HISTORIC AND DESIGN REVIEW COMMISSION

HDRC CASE NO: 2018-451
ADDRESS: 607 E LOCUST
LEGAL DESCRIPTION: NCB 1735 BLK 14 LOT 3
ZONING: MF-33 H
CITY COUNCIL DIST.: 1
DISTRICT: Tobin Hill Historic District
APPLICANT: Jose Calzada/Architectura SA
OWNER: Rafael Saavedra Sada/Aster Development LLC
TYPE OF WORK: Construction of three, three story townhomes
APPLICATION RECEIVED: September 19, 2018
60-DAY REVIEW: November 18, 2018
REQUEST:

The applicant is requesting conceptual approval to construct three, three story townhomes on the vacant lot addressed 607 E Locust.

SURROUNDING BUILDING HEIGHTS

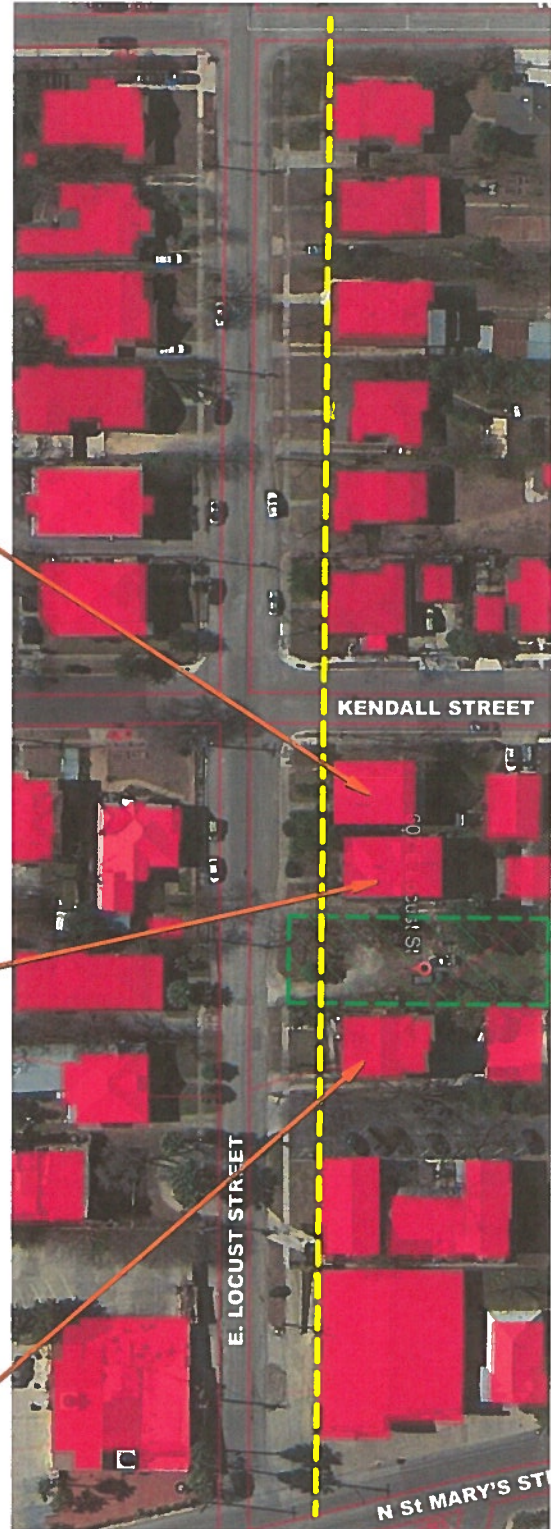
- g. **SCALE & MASS** – The applicant has proposed three detached 3-story units. One will be located along the street frontage of E Locust, and two will be located in the rear of the property. Per the submitted elevations, the ridgeline of the units is approximately 32'. Guideline 2.A.i stipulates that the height and scale of new construction should be consistent with nearby historic buildings and should not exceed that of the majority of historic buildings by more than one-story. Per the submitted elevations, the applicant has indicated that the 2-story historic

structures directly to the east and west are approximately 30-31 feet. While there are taller structures throughout the district, staff finds that a 2-1/2 story structure would be more appropriate for the overall context of the block, which includes 1-story structures immediately to the south. Staff finds that the overall height should be lowered to be more consistent with the Guidelines.

- ii. That the applicant explores 2.5-story massing options to respond to the dominant historic massing context of the neighborhood as noted in finding g.

1 FIRST FLOOR
 3/8" = 1'-0"

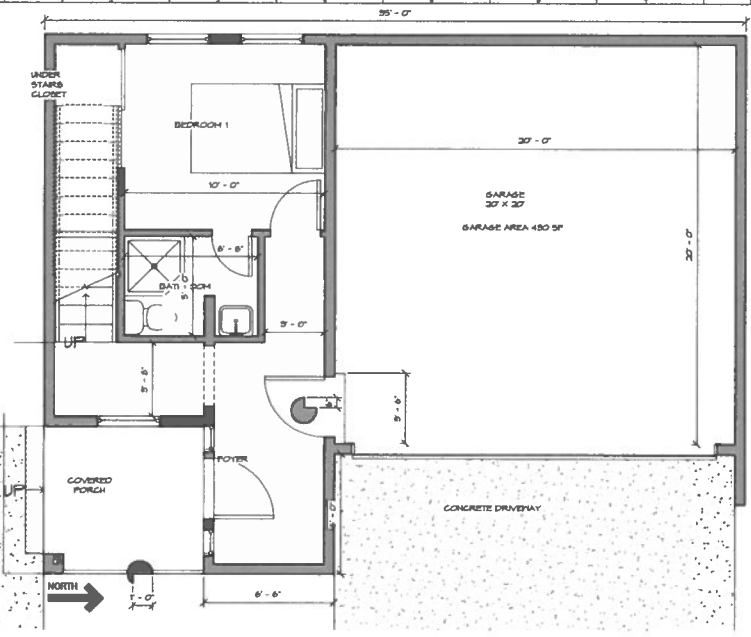
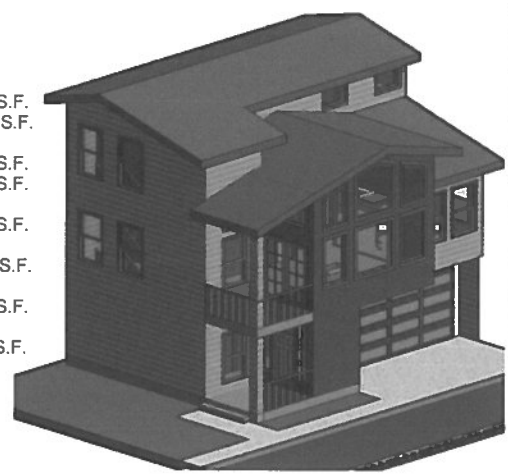
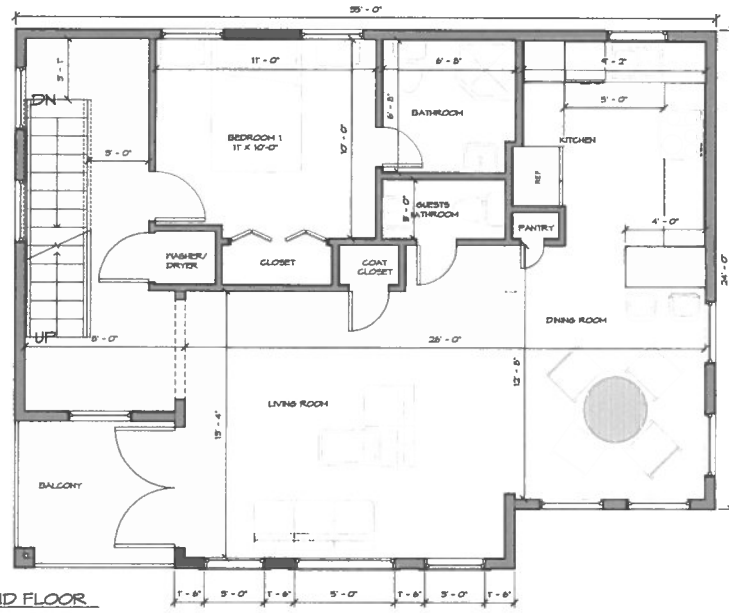
- h. **FOUNDATION & FLOOR HEIGHTS** – According to the Guidelines for New Construction 2.A.iii., foundation and floor heights should be aligned within one (1) foot of neighboring structure's foundations. Throughout this block, the foundation heights of historic structures are between two and three feet. The elevations for the units are approximately 1 foot with slab on grade construction. Staff does not find the proposal consistent with the Guidelines.

- j. **PORCH** – The applicant has proposed a double height recessed porch on the east side of the front unit. The porch features a traditional railing based on the submitted renderings with a depth of approximately 8 feet. According to the Historic Design Guidelines, new construction should not attempt to mirror or replicate historic features, and new structures and design elements should not be so dissimilar as to distract from or diminish the historic interpretation of the district. The conceptual porch configuration pulls from the historic structure located 2 houses to the west. However, this precedent features a higher foundation height and stairs that engage the streetscape leading from the front porch. Staff finds that further articulation of the porch as an element geared towards the pedestrian experience is required to be more consistent with the Guidelines and development pattern of the block and the district.

- iv. That the applicant incorporates a foundation height of at least 18 inches to be more consistent with the foundation heights of nearby historic structures as noted in finding h.
